Millcreek City Council

**Subject: Comments of Millcreek
Granite's Responses to Utah DAQ Requests for Information, DAQE-
NN161200001A-24
New I-80 Aggregate Mining Facility**

**Subject: Comments of Millcreek
 Intent to Approve DAQE-IN161200001-23
 New I-80 Aggregate Mining Facility**

Comments on Granite's Responses to the Utah DAQ Via Letters Dated July 4 and July 16, 2024

Figure 8: Comparison of 10 m height temperature between observations and WRF model results for SLC weather station from 2021 to 2023.

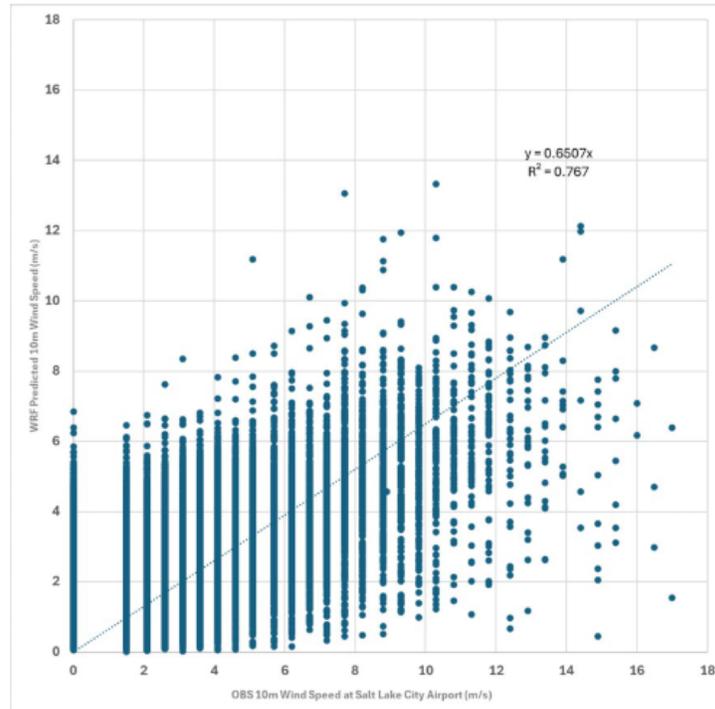
(a) The validation of the current model with SLC data for wind speed ($R^2 = 0.77$) as presented by Granite's consultant is not acceptable. In fact, the graphical presentation of this in Figure 8 of the modeling report, reproduced below, shows that even with very well defined geometry information as well as direct SLC meteorological data used for the comparison, the WRF pseudo-meteorological predictions are very inaccurate and subject to large errors at the SLC airport. We have no confidence, given these results, that the WRF model as currently used is providing useful or accurate data for use in AERMOD at the far more complex mine site.

Therefore, DAQ should ask Granite to explain how the SLC validation for wind speed can be improved. Specifically, and at a minimum, Granite should re-model using a spatial resolution of 444 meters (which is 1/3 of the 1.33 km resolution and the next higher level of spatial resolution in WRF) instead of the 1.33 km currently used. Not only will this likely improve the SLC validation, the 444 meter resolution is warranted given the complex topography at the mine site itself, which is not resolved well at the 1.33 km spatial scale. The 444 meter resolution would be much more reflective of canyon topography and winds, and would likely result in additional throughput reductions in order to avoid further NAAQS violations.
